# 1953 - 1954 Corvette: Service News: Powerglide Clutch Interference

**Subject:** Powerglide Clutch

**Model and Year:** 1953 - 1954 Corvette

**Date:** October, 1957 - Volume 29- Number 10

*Fig. 2—Powerglide Valve Body Re-worked.*

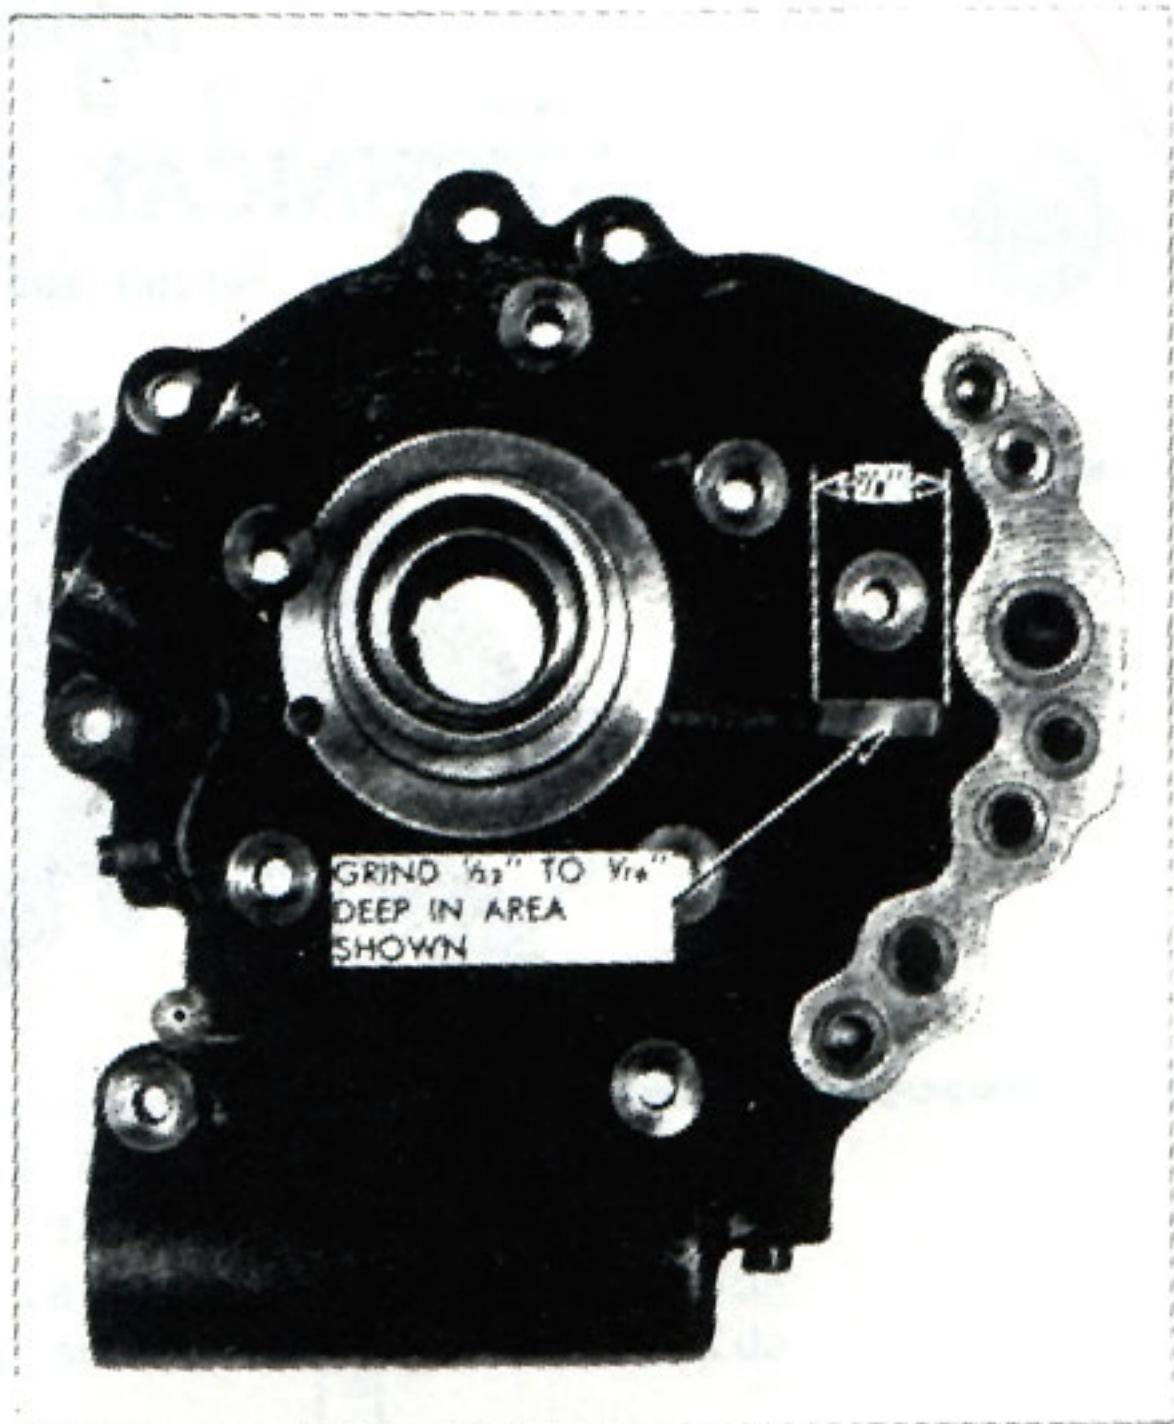
Due to limit stack conditions, a point of interference is possible when using a service replacement clutch drum or clutch assembly in 1953-54 Powerglide transmissions. The difficulty is caused by a ledge incorporated on the front face of a service replacement clutch drum, which can contact an embossed area on the valve body casting.

The interference can only be occasioned when using the following parts for replacement:

3740045 Clutch Drum Assembly

3742454 Clutch Assembly

3743840 Clutch Assembly

3748702 Clutch Assembly

Where clutch drum-valve body interference is noted when installing one of the above assemblies the valve body must be reworked to obtain drum operating clearance, as shown in Figure 2.
